Pines Dining Hall + Servery Addition

Addendum No. 1

Issued 04 May, 2018

DGBK Project No. 17-110

A-401

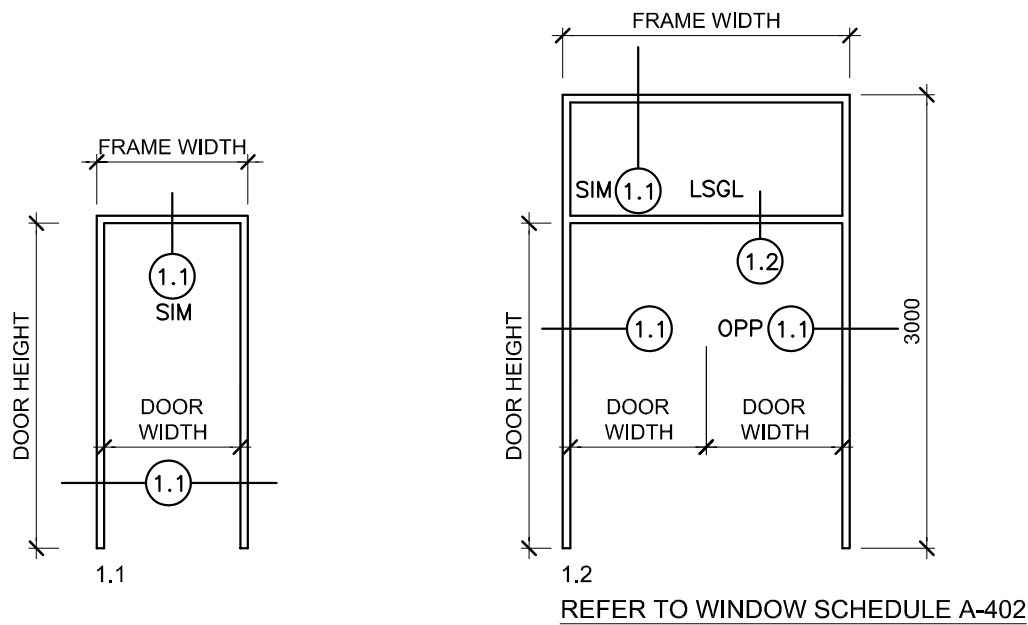
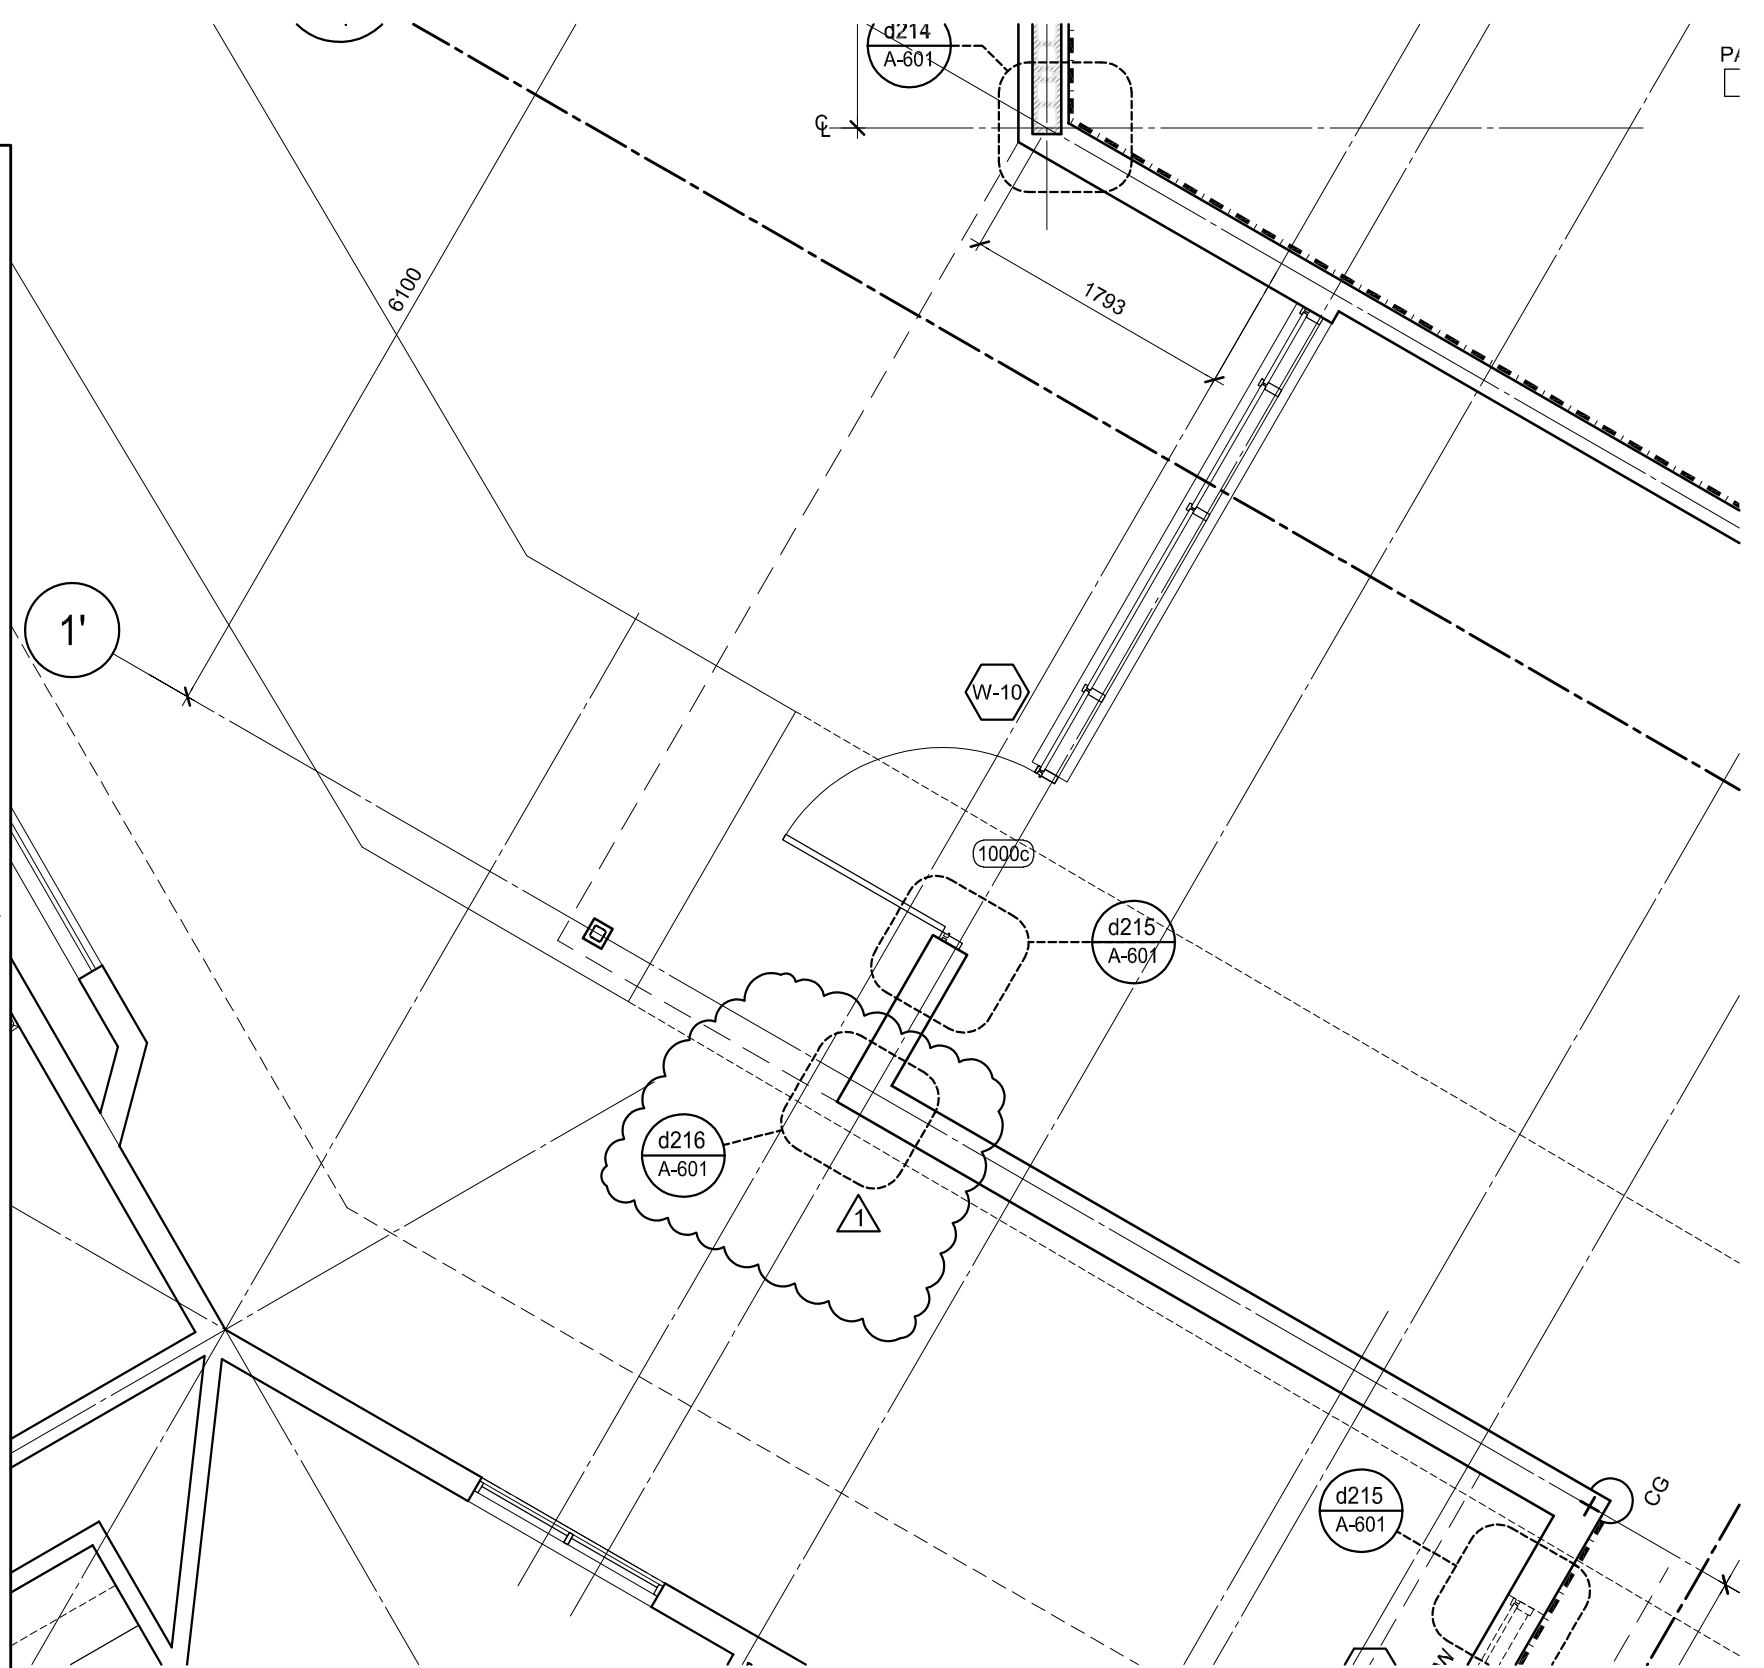
Item 6 Drawing A-401 & A-402
Note the following clarification:

1. Extent and layout of Fibre Reinforced Cementitious Panels and Planks on North, East, South and West Elevations.

1. Existing Irrigation System –

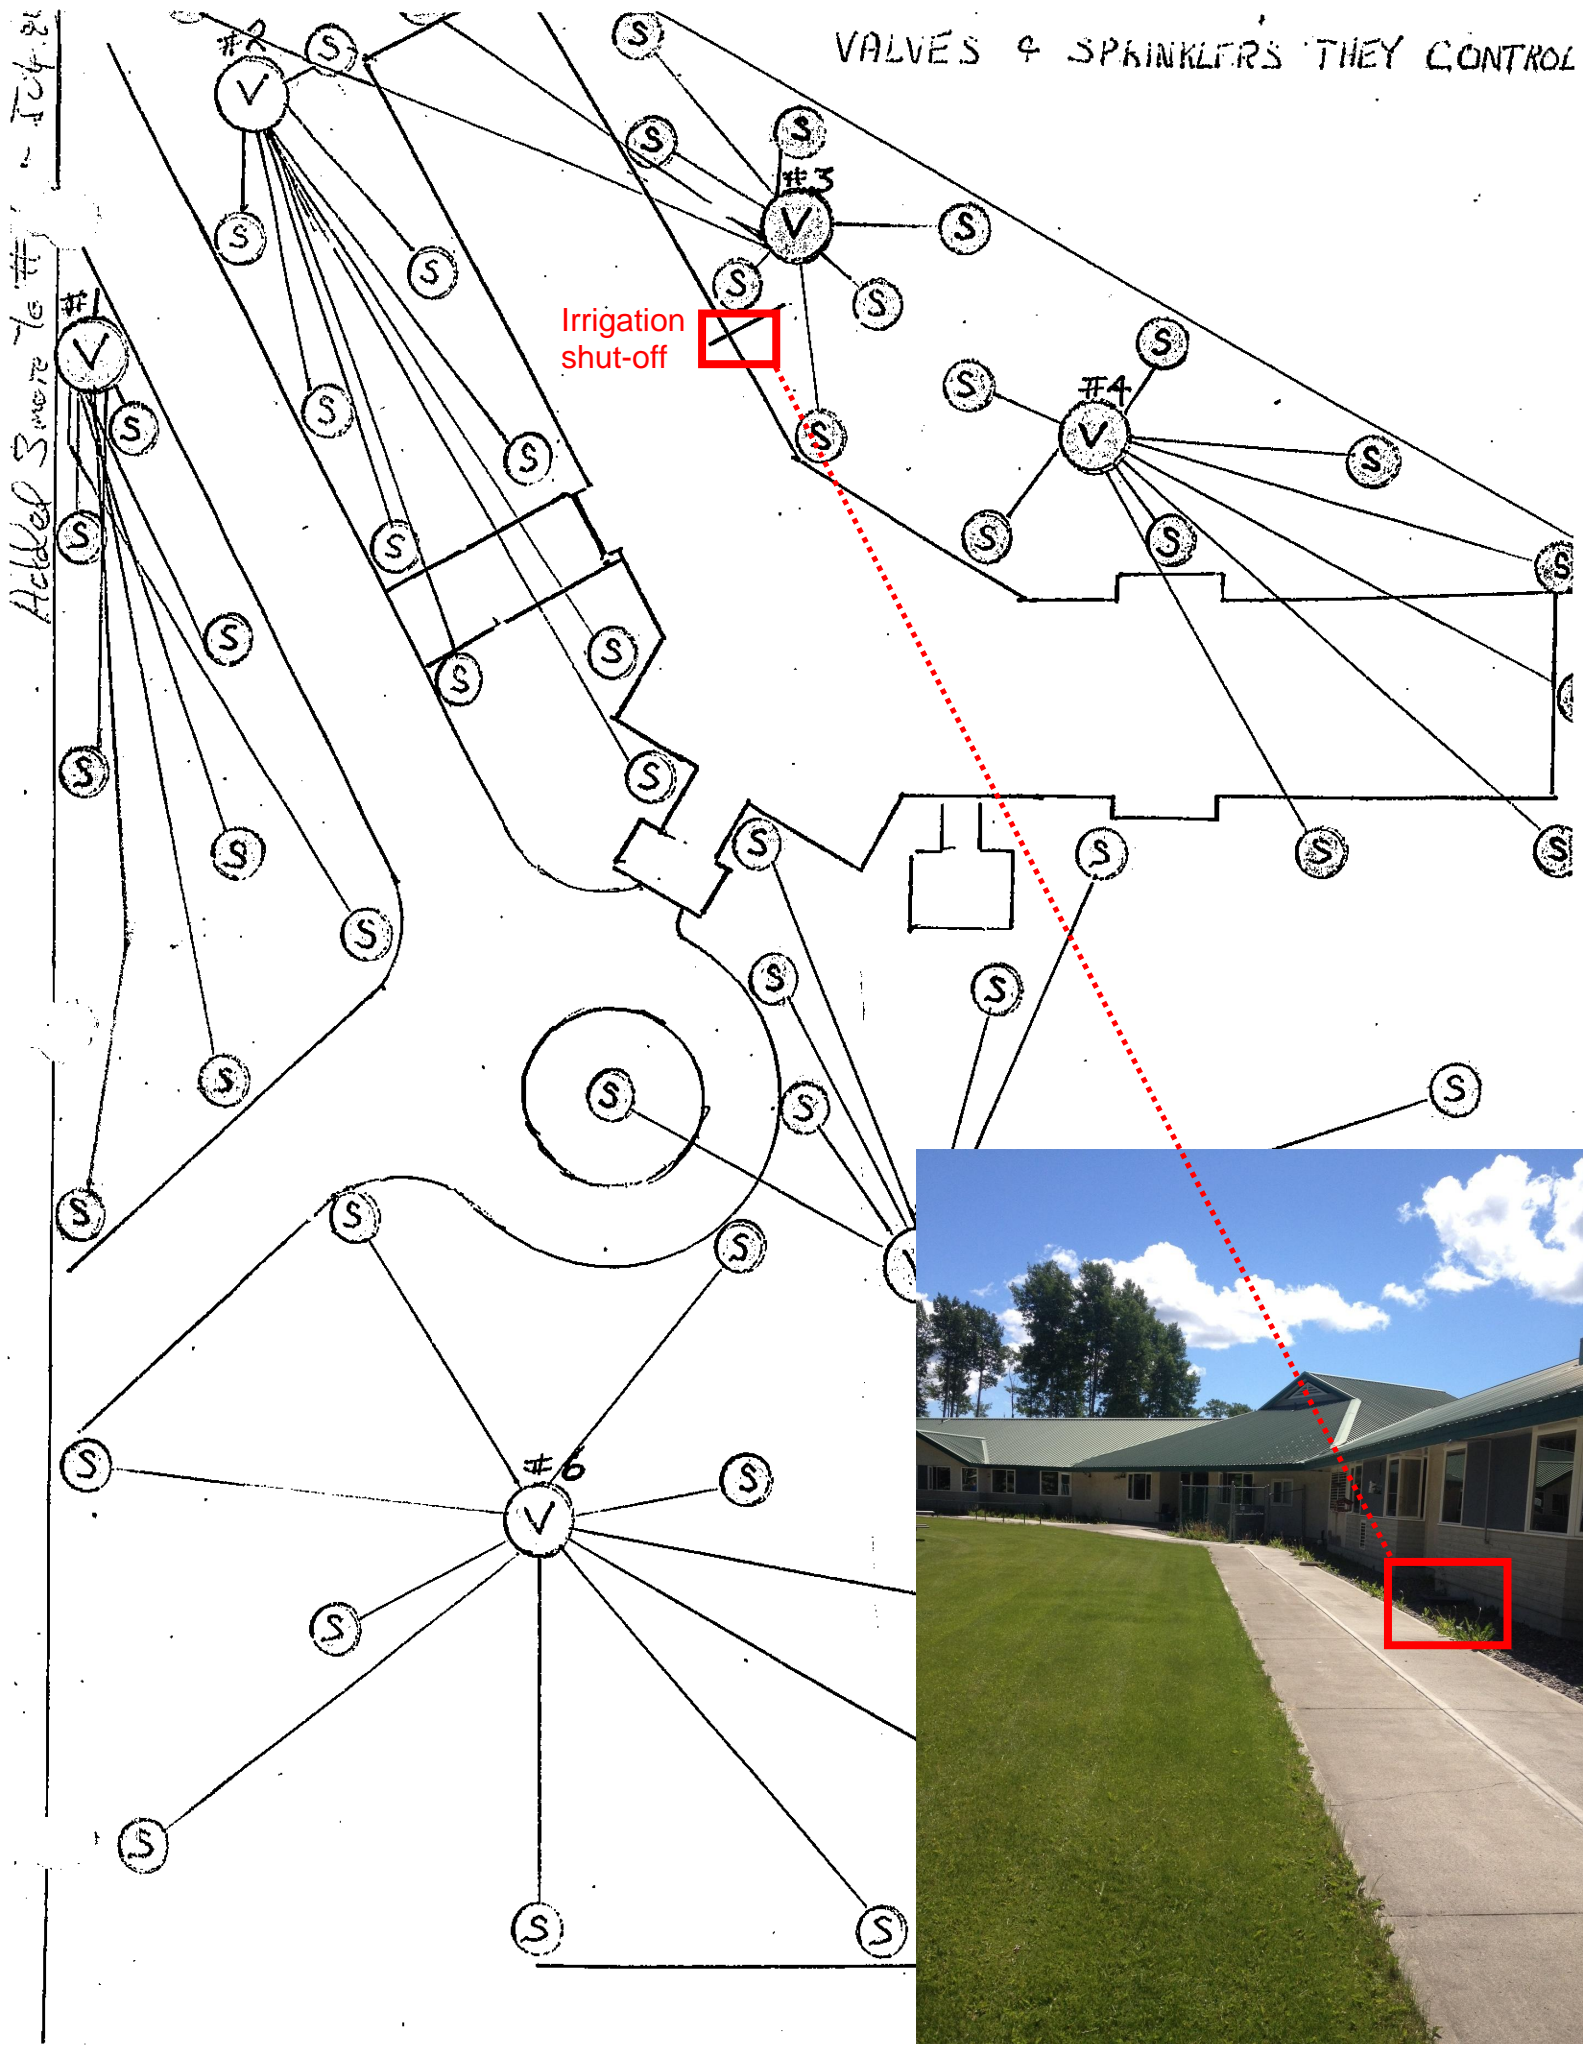
There is an existing irrigation system in the area of construction. The existing system is to be turned off at the rear of the building before demolition works. The existing system not under the new building footprint is to be retained and protected. Sprinkler heads and irrigation lines that are located in the new build area are to be removed and irrigation lines capped.
